**DRAINAGE LETTER REPORT**  
for  
**LOT 1A, FALCON MARKETPLACE**

7520 Falcon Market Place  
Falcon, Colorado

**November, 2023**

**PCD File No: PPR-236**

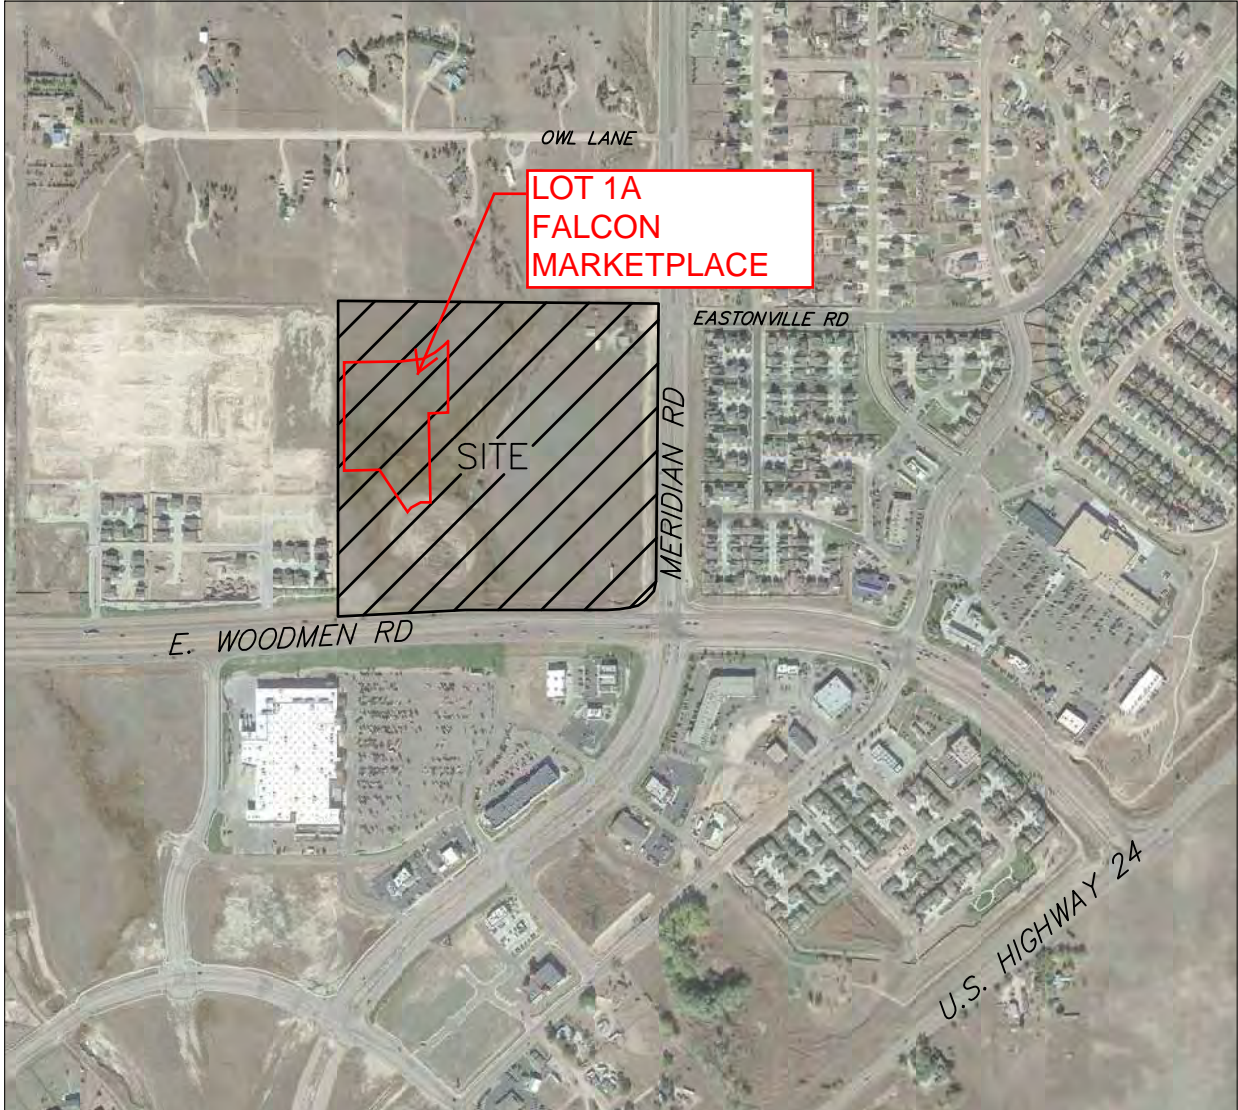
**Unresolved Review 1 Comment:**  
- Please state what the difference in runoff rates is between the previously approved subdivision drainage report versus this proposed development.

**PROPOSED  
DRAINAGE  
PLAN**

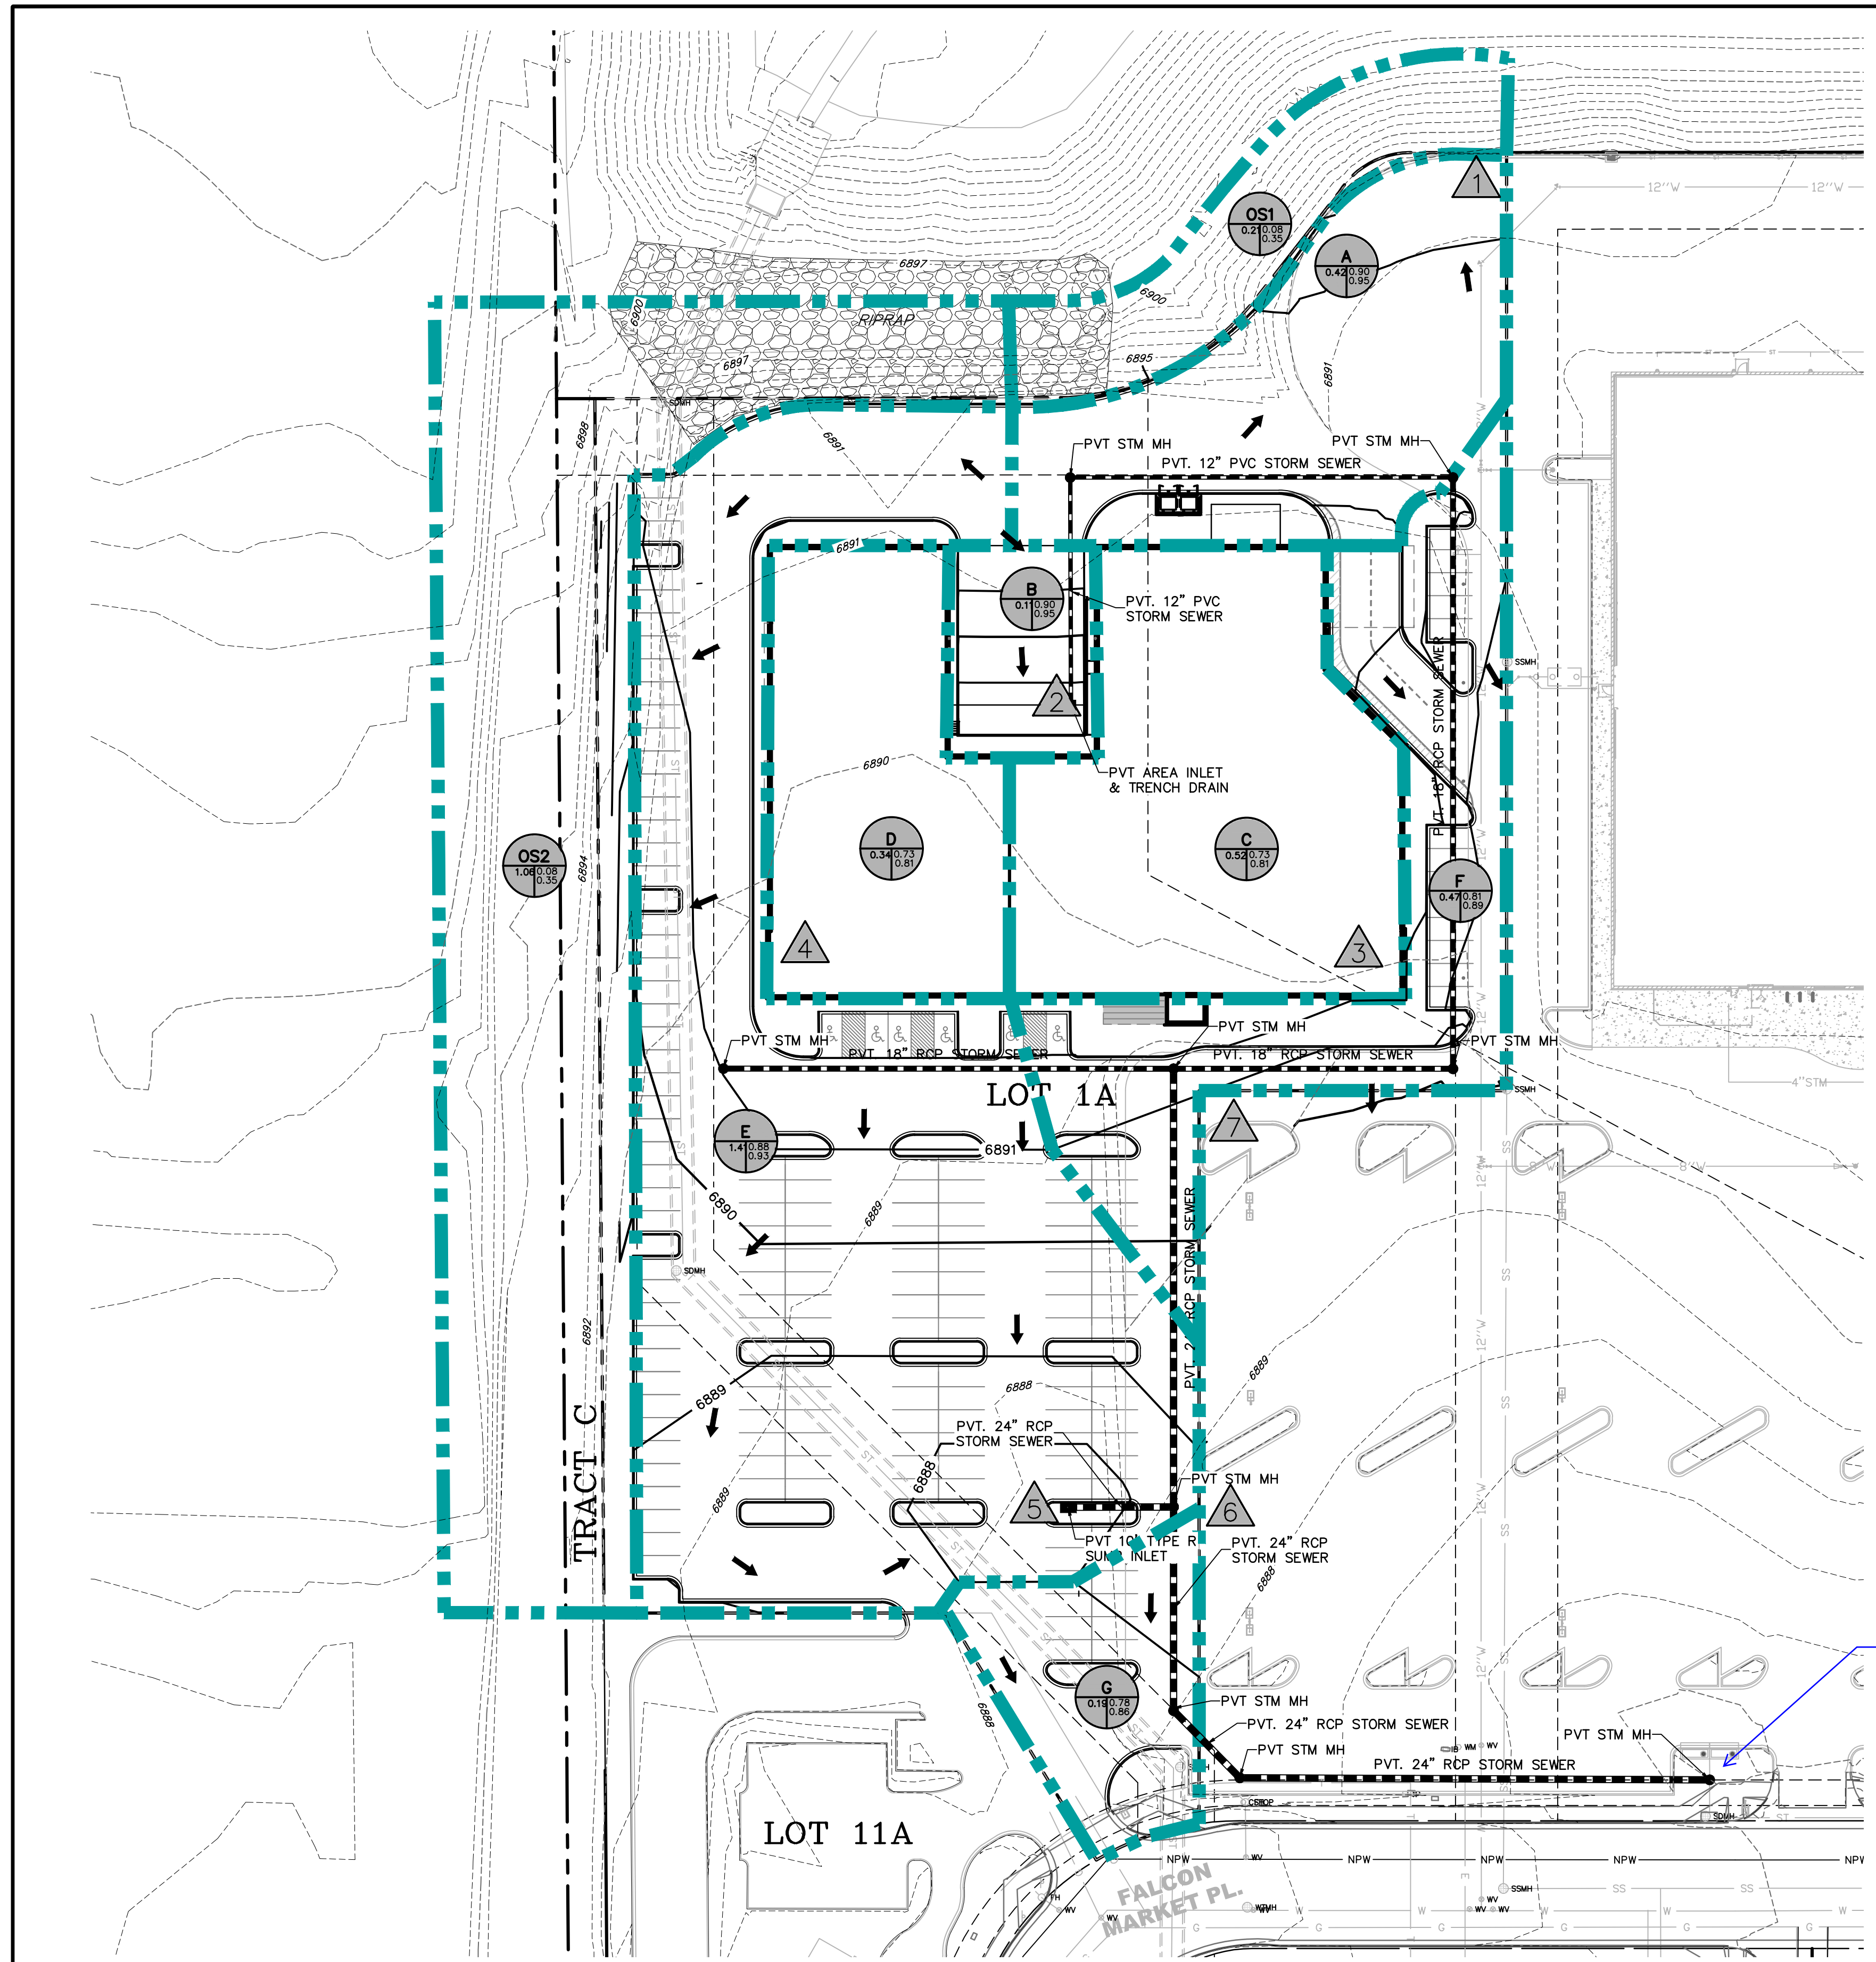
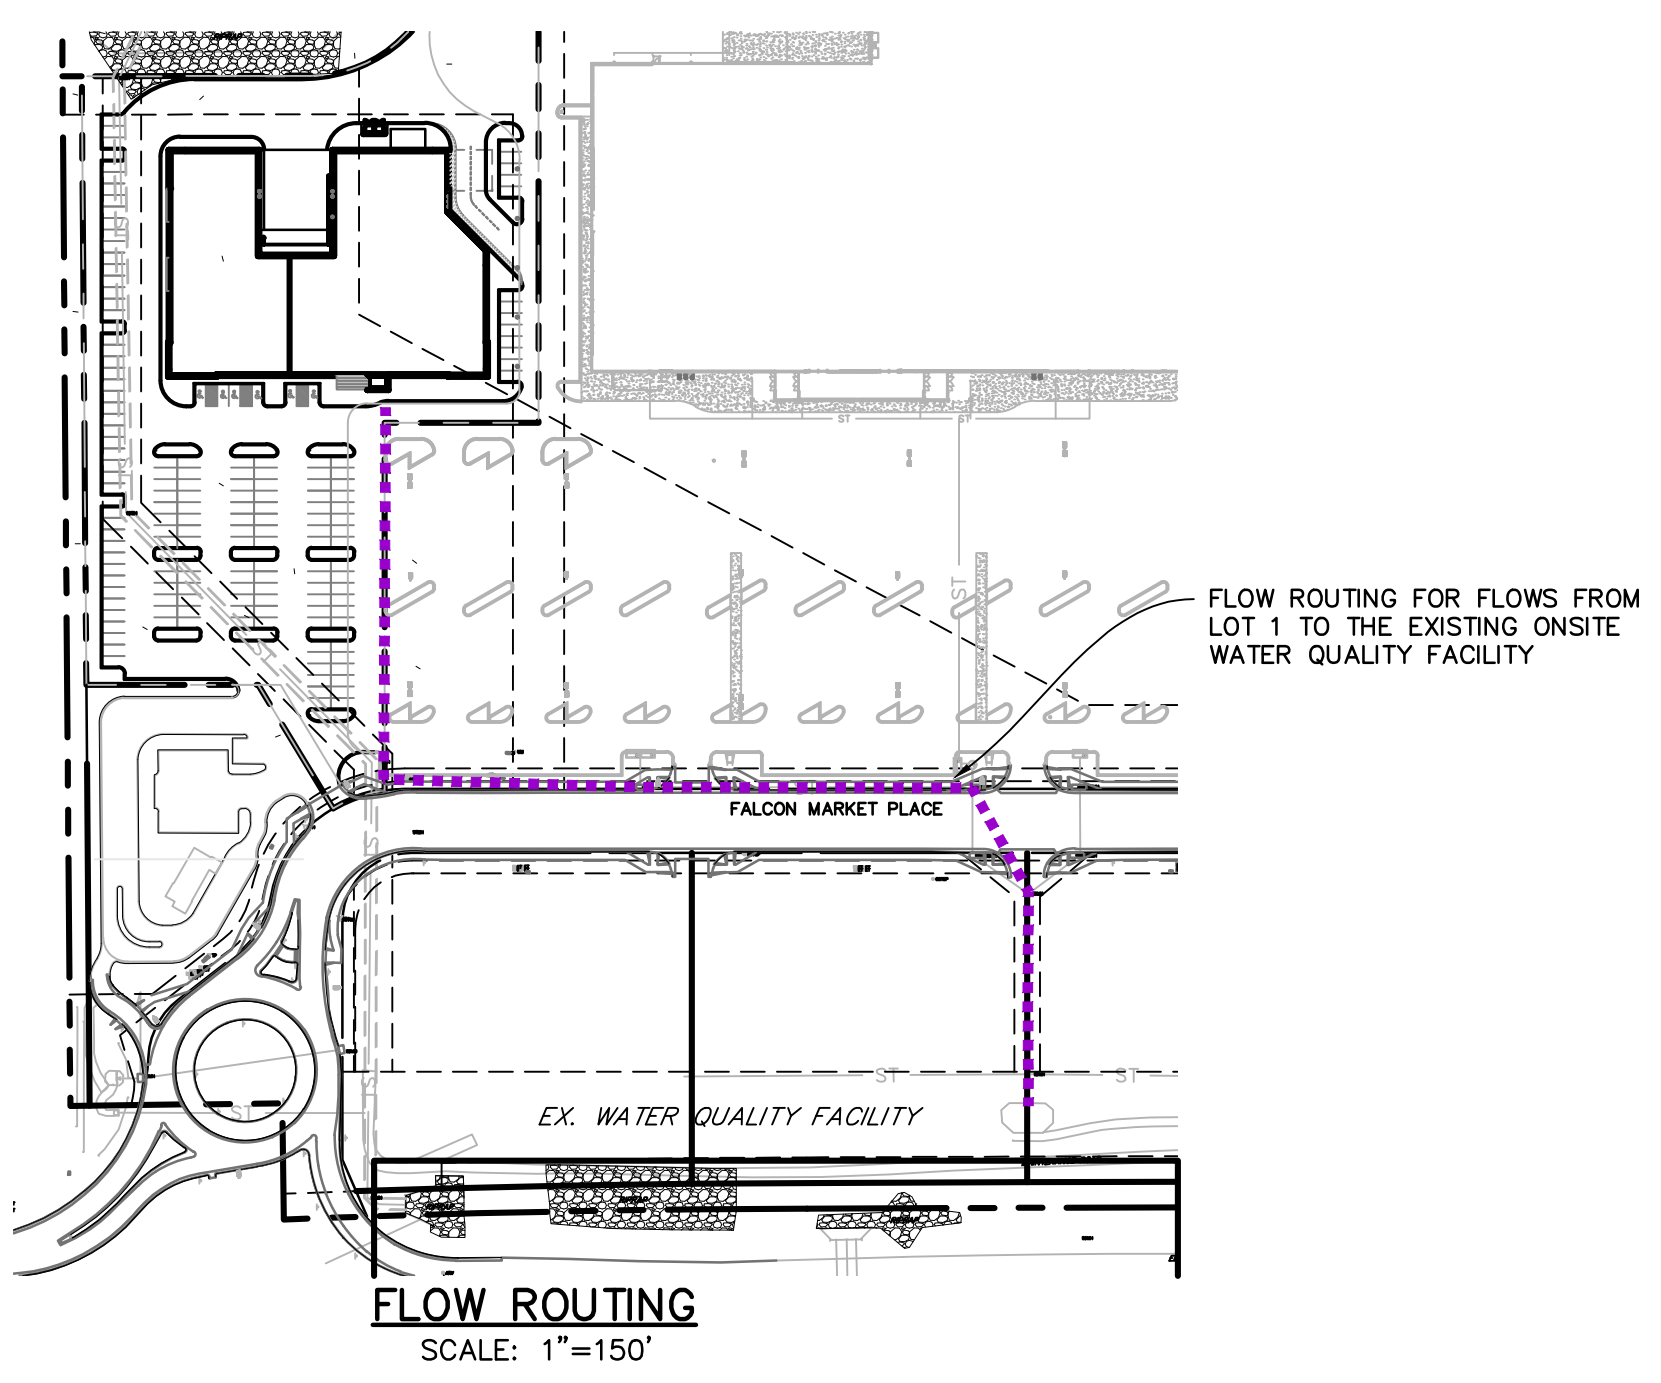
Unresolved Review 1 Comment:  
- Identify the ultimate flow at this location and compare to what was indicated in the Falcon marketplace drainage report
